11-1 CHECKING PRESTRESS SHOP DRAWINGS

Example

Consider a two-span CIP/PS box girder bridge with skewed supports and horizontal curvature.

Figure 8 - Duct Profile

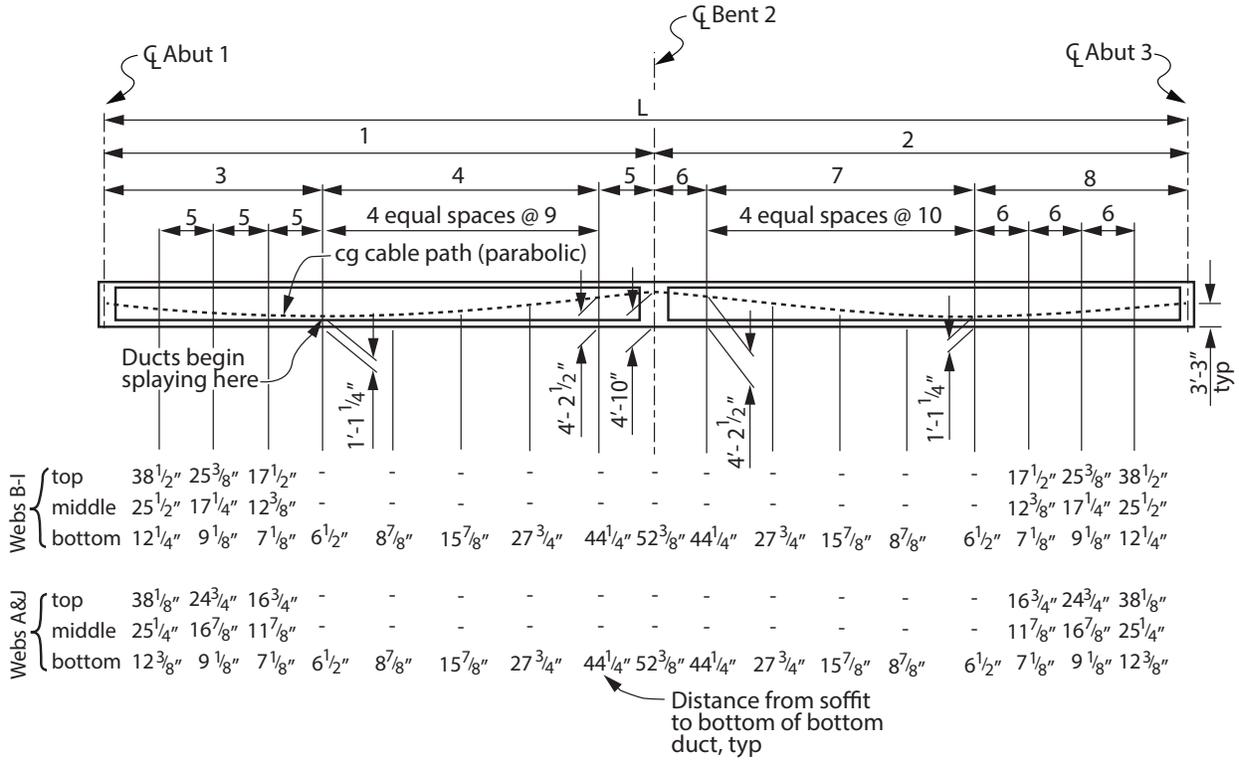
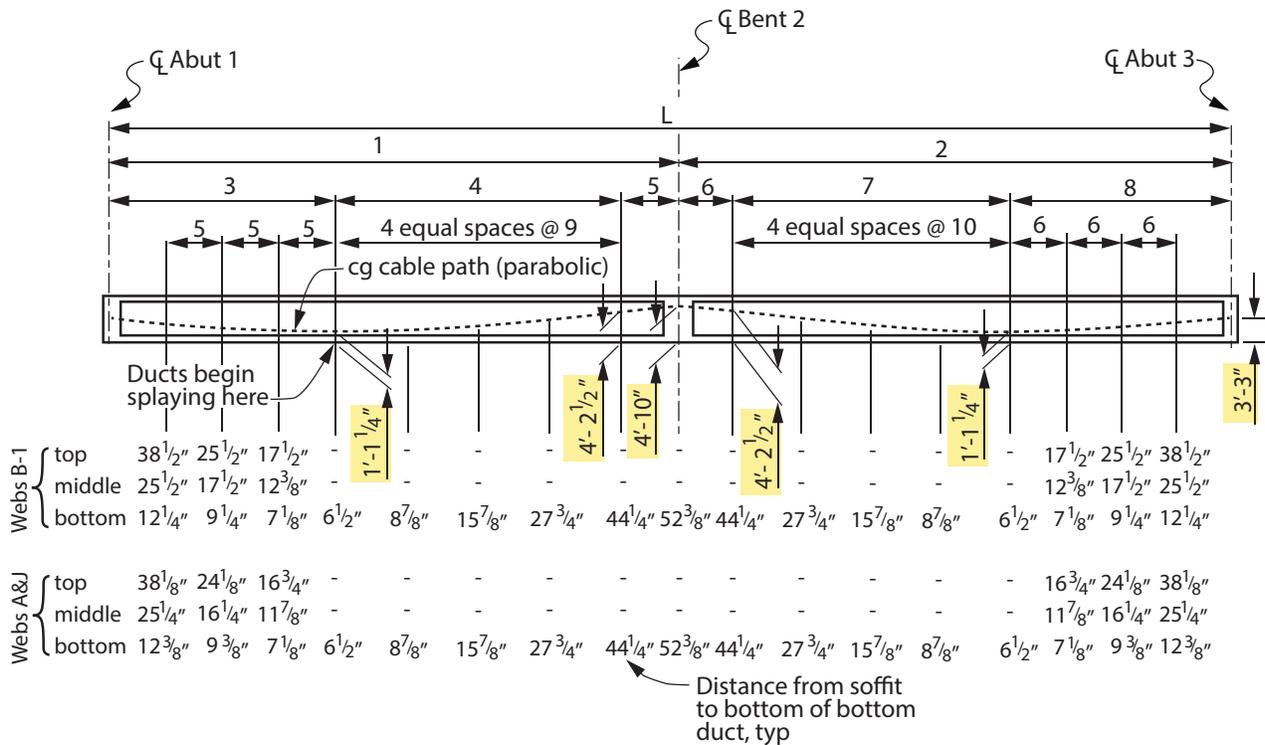
STEP 1: Compare the control points along the cable path c.g. (Fig. 8) with the structure plans (Fig. 7).

The vertical dimensions to compare in this example are: 3'-3", 1'-1 1/4", 4'-2 1/2", and 4'-10". These values must compare exactly, and in this case they do. Be sure to highlight each checked item on the shop plans file copy as you proceed. (Fig. 9)

The layout is provided in Figure 8 which represents the shop plan duct profile as provided to the Engineer. The c.g.s. of each control point was already checked in step 1. Now check the LOL for each of these control points (use calculated values). The tolerance is $\frac{1}{4}$ ".

- Span 1 low point: $13.25" - 6.72" = 6.53"$ 6.50" provided, OK
 - Span 1 inflection point: $50.5" - 6.21" = 44.29"$ 44.25" provided, OK
 - Bent 2 high point: $58" - 5.69" = 52.31"$ 52.38" provided, OK
- Span 2 locations are the same by symmetry.

Figure 8 anchorage location = 3'-3" (39"). The anchorage layout is OK.

Figure 12 - Stressing Sequence (Shop Plan Drawing)

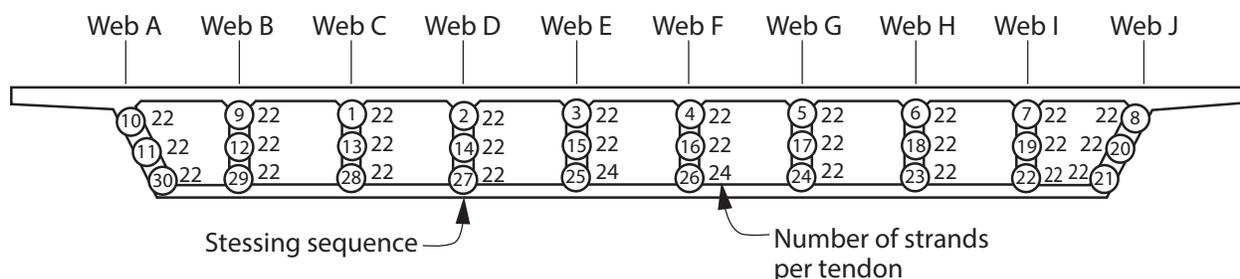
Additionally, check to make sure the chosen number of strands and tendons adds up to the required total. For this check, use the stressing sequence drawing (Figure 12).

$$No.strands = 28 * 22 + 2 * 24 = 664 \text{ strands} \quad \text{OK}$$

Finally, the check of item 3) for temporary force variation can be done by inspection. Looking at Figure 12, the maximum number of strands is 24 in webs E and F. So long as any one girder does not have more than a 24 strand difference from any other girder during any given sequence, this criteria is met. By inspection, the maximum variation occurs after sequence 25. At this moment in time, girder E will have a 24 strand difference from girders A-D and F. This is the maximum difference allowed so it is OK.

Figure 13 - Average C.G. from LOL Checked (Shop Plan Drawing)

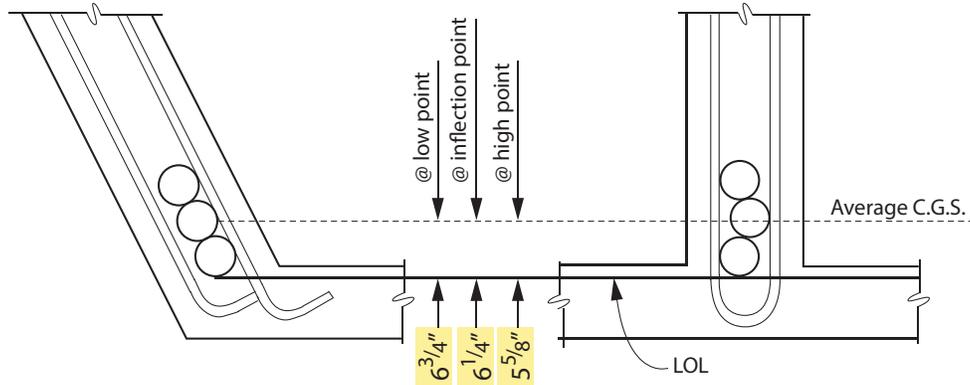
Average c.g.s. from bottom duct LOL:

$$\text{cg@ low point} = (2[22(\frac{4.2}{2} + 0.5) + 22(\frac{4.2}{2} + 3.76 + 0.5) + 22(\frac{4.2}{2} + 3.76 + 3.76 + 0.5)] + 6[22(\frac{4.2}{2} + 0.5) + 22(\frac{4.2}{2} + 4.17 + 0.5) + 22(\frac{4.2}{2} + 4.17 \times 2 + 0.5)] + 2[24(\frac{4.45}{2} + 0.71) + 22(\frac{4.45}{2} + 4.31 + 0.5) + 22(\frac{4.45}{2} + 4.31 + 4.17 + 0.5)]) / (664 \text{ strands}) = 6.72 \text{ in}$$

$$\text{cg@ inflection point} = (2[22(\frac{4.2}{2}) + 22(\frac{4.2}{2} + 3.76) + 22(\frac{4.2}{2} + 3.76 + 3.76)] + 6[22(\frac{4.2}{2}) + 22(\frac{4.2}{2} + 4.17) + 22(\frac{4.2}{2} + 4.17 \times 2) + 2[24(\frac{4.45}{2}) + 22(\frac{4.45}{2} + 4.31) + 22(\frac{4.45}{2} + 4.31 + 4.17)]) / (664 \text{ strands}) = 6.21 \text{ in}$$

$$\text{cg@ high point} = (2[22(\frac{4.2}{2} - 0.5) + 22(\frac{4.2}{2} + 3.76 - 0.5) + 22(\frac{4.2}{2} + 3.76 + 3.76 - 0.5)] + 6[22(\frac{4.2}{2} - 0.5) + 22(\frac{4.2}{2} + 4.17 - 0.5) + 22(\frac{4.2}{2} + 4.17 \times 2 - 0.5)] + 2[24(\frac{4.45}{2} - 0.71) + 22(\frac{4.45}{2} + 4.31 - 0.5) - 22(\frac{4.45}{2} + 4.31 + 4.17 - 0.5)]) / (664 \text{ strands}) = 5.69 \text{ in}$$

Figure 14 - Anchorage Area PT Duct Layout (Shop Plan Drawing)

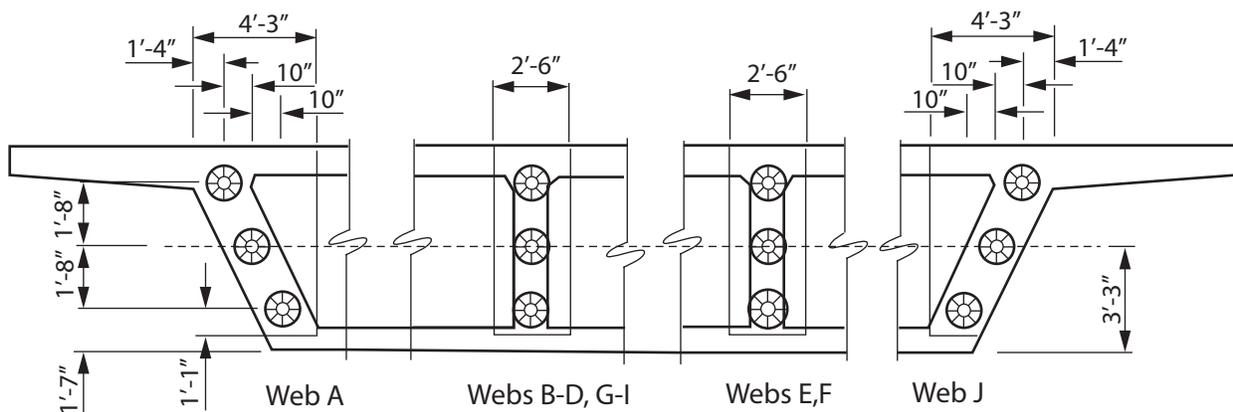
Next, check the c.g.s. at the anchorage areas. The goal here is to make sure the anchorage layout on the shop drawings (Figure 14) matches the Figure 8 dimensions.

$$\text{Anchorage Area cg} = \frac{[19(22 \times 8 + 24 \times 2) + 39(22 \times 10) + 59(22 \times 10)]}{664} = 38.88''$$

Figure 15 - Cable Path Parabolas at Web E

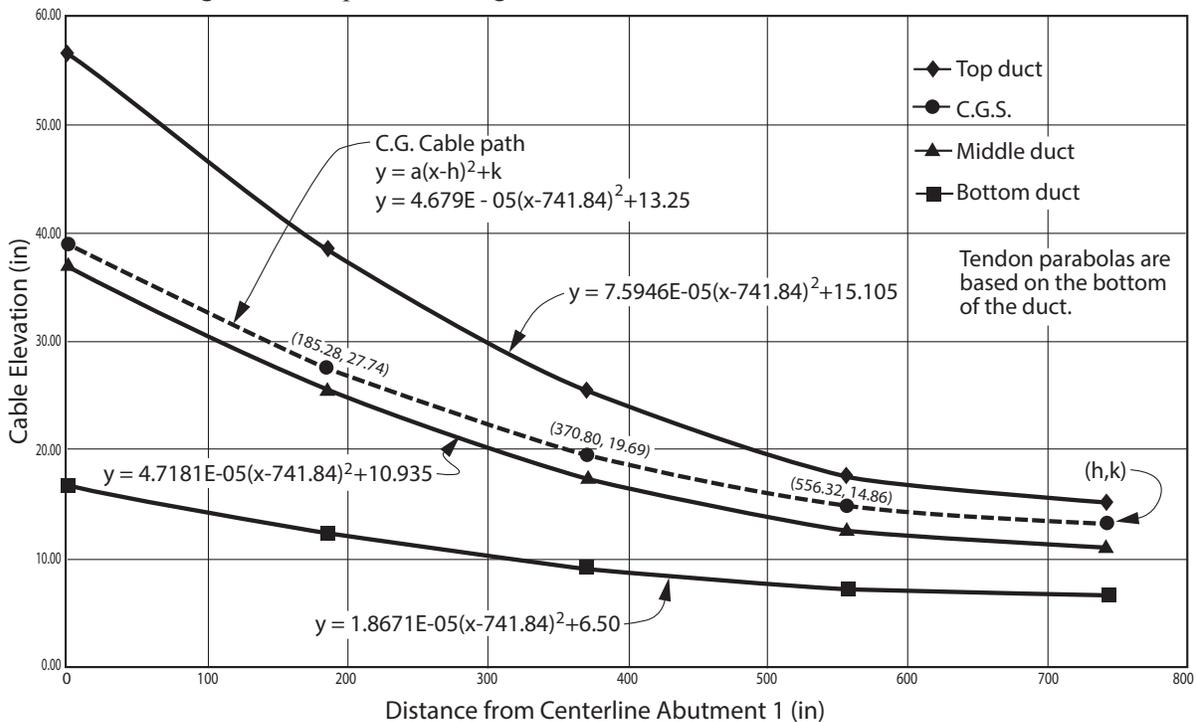
To check the shop drawing value for each tendon, create parabolas for each tendon using the known end points. The first intermediate point is at location $x = 185.28$. For the bottom duct the vertical profile at this location is:

$$y = 0.000018671*(185.28-741.84)^2+6.50 = 12.28in$$

The shop drawing value is $12 \frac{1}{4}"$. Value checks out OK.

The second intermediate point is at location $x = 370.80$. Checking the 2nd intermediate point for the bottom duct:

$$y = 0.000018671*(370.80-741.84)^2+6.50 = 9.07in$$

The shop drawing value is $9 \frac{1}{8}"$. Value checks out OK.

The third intermediate point is at location $x = 556.32$. Checking the 3rd intermediate point for the bottom duct:

$$y = 0.000018671*(556.32-741.84)^2+6.50 = 7.14in$$

The shop drawing value is $7 \frac{1}{8}"$. Value checks out OK.

$$y = 0.000043895(231.84)^2+6.5=8.86in$$

Shop plan value is $8 \frac{7}{8}"$, value checks out OK.

Figure 16 - Bearing Plate Angle

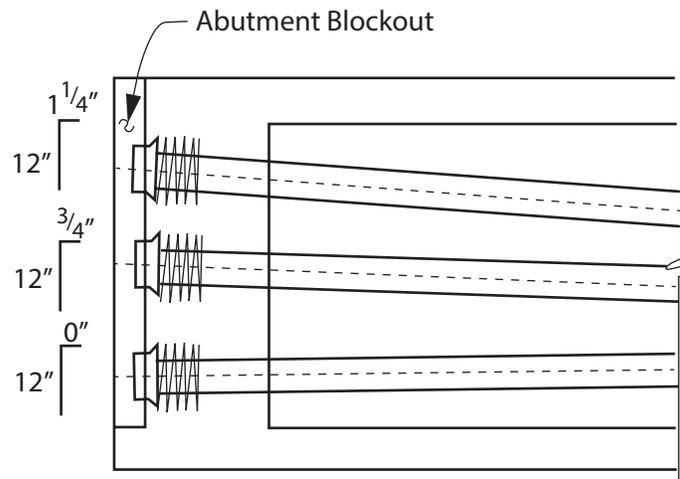
The bearing plates need to be cast perpendicular to the tendon. To verify this, the slope of the tendon itself at the anchorage and the slope of the bridge at that location must be calculated. This verification can be accomplished graphically (by drawing to scale) or mathematically as shown below.

The net slope of the bottom duct is therefore: (-0.0277+0.01479) = -0.0129.

The shop plans indicate 0. The percentage difference is 1.29% < 2.0%, this checks OK.

$$\text{Net slope} = -0.0700 + 0.01479 = -0.0552$$

The shop plans indicate -0.75"/12" = -0.0625. The percentage difference is (0.0625-0.0552)*100 = 0.73% < 2.0%. This checks OK.

$$\text{Net slope} = -0.113 + 0.01479 = -0.0982$$

The shop plans indicate $-1.25''/12'' = -0.1042$. The percentage difference is $(0.1042 - 0.0982) * 100 = 0.6\% < 2.0\%$. This checks OK.

Figure 17 - Plan View Blockout Dimensions (Shop Plan Drawing)

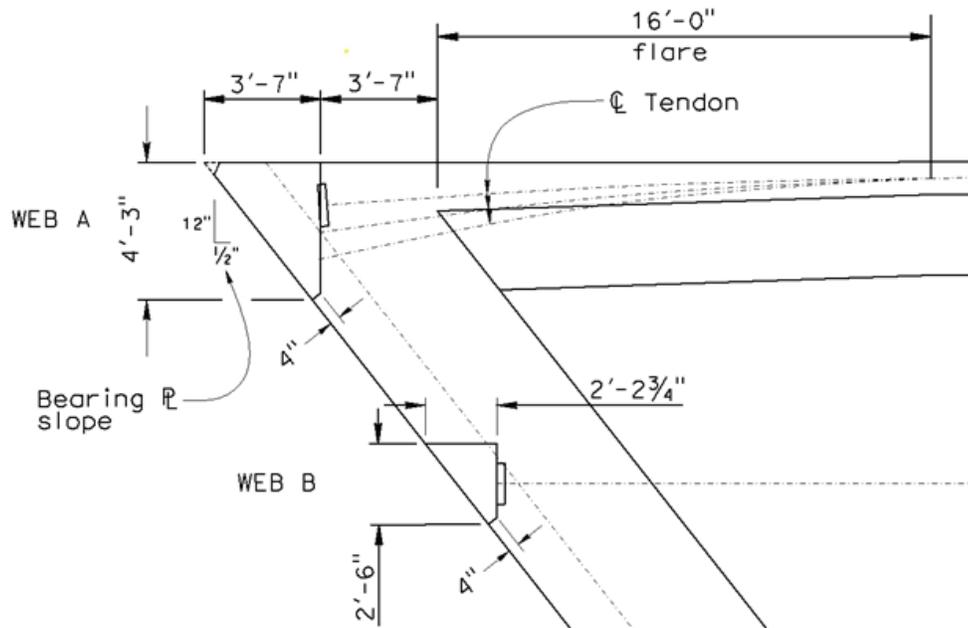
In Figure 17, dimensions are provided on the shop drawings indicating the depth of the breakout as well as the horizontal slope of the bearing plate, if any. For Web A, a horizontal slope is necessary (relative to the plane of the breakout) because at exterior girders the path needs to curve inward to allow enough room for the anchorage hardware and edge distance.

WEB A: $Blockout\ Depth = (4.25 + 0.333) * \tan(37.898) = 3.57ft$
3'-7" was provided, OK.

WEB B: $Blockout\ Depth = (2.5 + 0.333) * \tan(37.898) = 2.21ft$
2'-2 3/4" was provided, OK.

$$\tan^{-1}\left(\frac{1.333\ ft - 0.5\ ft}{19.58\ ft}\right) = 2.44^\circ$$

Provided: 1/2" in 12" = 2.38°, OK.

Figure 18 - Single Span Bridge Longitudinal Section (Shop Plan Drawing)

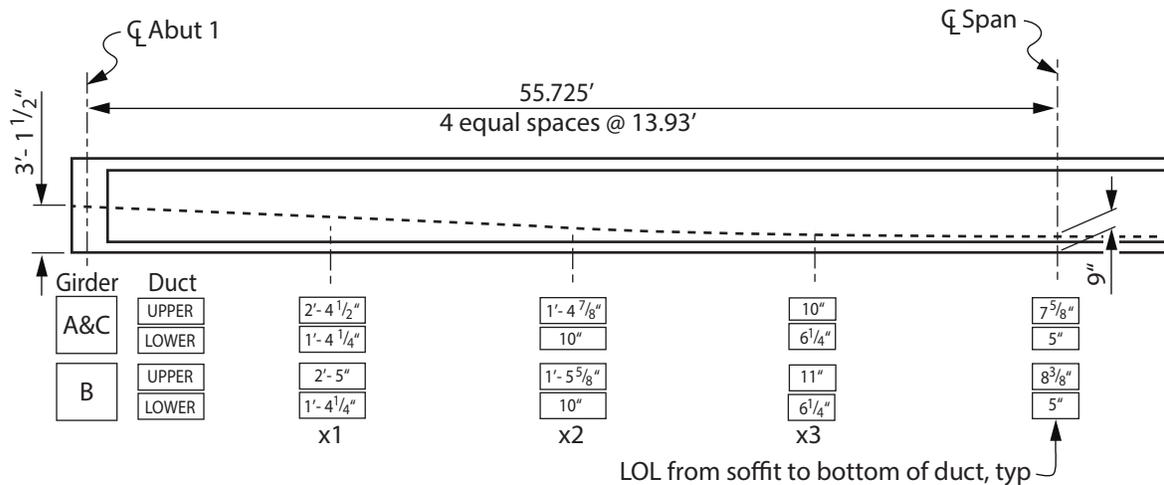
For this single span bridge example, the cable path is symmetrical about the centerline of the span. When shop plans use this format, one needs to compare the c.g.s. location based on the structure plans to the c.g.s. as located by a weighted average of the dimensions provided in the boxes (based on the PS shop plans). One method to perform this check is shown in Figure 19.

The soffit to c.g.s. using the shop plans is calculated by using a weighted average of the strand layout line locations provided. Take into account the diameter of the duct and the “z” value for each duct size. Tolerance is $\frac{1}{4}$ ”.

The profile of each individual duct may not be parabolic, therefore, plot the layout of each tendon on a graph to ensure there are no kinks in the profile.
